TECHNICAL BULLETIN

[Issue No.] FA-A-0069

[Title] Changes of CC-Link one-touch connector plug (for communication, power supply, and FG) covers

[Relevant Models] A6CON-L5P, A6CON-TR11, A6CON-PW5P, and A6CON-PW5P-SOD

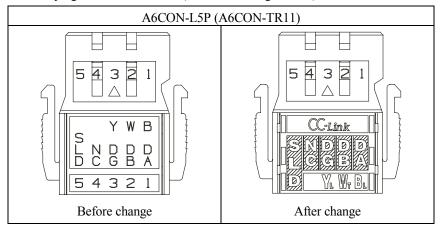
(2) Improved visibility

The font of the characters on the cover has been changed to bold. This change improves visibility.
